STAFF REPORT ACTION REQUIRED

Outdoor Café Encroachment Request 1060-1064 The Queensway

Date:	April 27, 2009
To:	Etobicoke York Community Council
From:	Curtis Sealock, District Manager, Municipal Licensing and Standards
Wards:	Ward 5, Etobicoke Lakeshore
Reference Number:	ML& S Folder No. 09-116752

Attachment 1: Plot Plan, Patio Floor Plan and Patio Fence Details

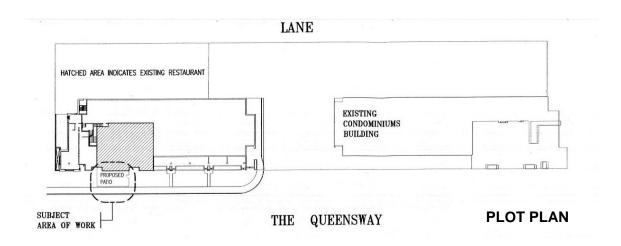
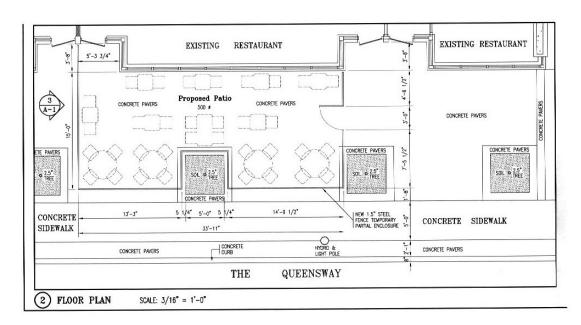
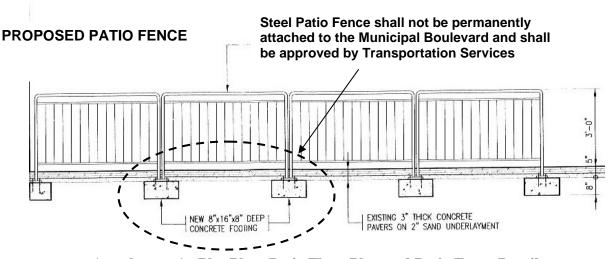
- (a) The temporary steel fence enclosing the patio shall be located not less than 0.50 metres from the north edge of the existing concrete sidewalk;
- (b) The steel patio fence shall not be permanently attached to the municipal boulevard; and
- (c) The outdoor patio is for seasonal use only.

In addition, Bell Canada requested for special cautions in carrying out the construction work because of the proximity of their existing services underground, allowing for a minimum clearance of 0.60 metres to be maintained and hand digging to be used when crossing the Bell plant.

- (a) To limit the noise, no live or taped music to be played;
- (b) The hours of operation shall be limited to 11 p.m.;
- (c) Smoking at the patio is prohibited; and
- (d) The design and materials of the patio shall cope with the existing building and environment.

- 7. Subject to the approval of Transportation Services, the proposed 0.91 metres high steel patio fence shall be located not less than 0.50 metres from the northern edge of the existing concrete sidewalk, and not be permanently attached to the municipal boulevard.

- 9. A clearance of 0.60 metres to the existing Bell Plant shall be maintained and only hand digging is allowed when crossing a Bell Plant.
- 10. The owner to operate the boulevard café in strict compliance with the requirements as stipulated under Toronto Municipal Code, Chapter 591, Noise, and the prohibition of live bands under Section 320-23G of the Etobicoke Zoning By-law, Chapter 320.
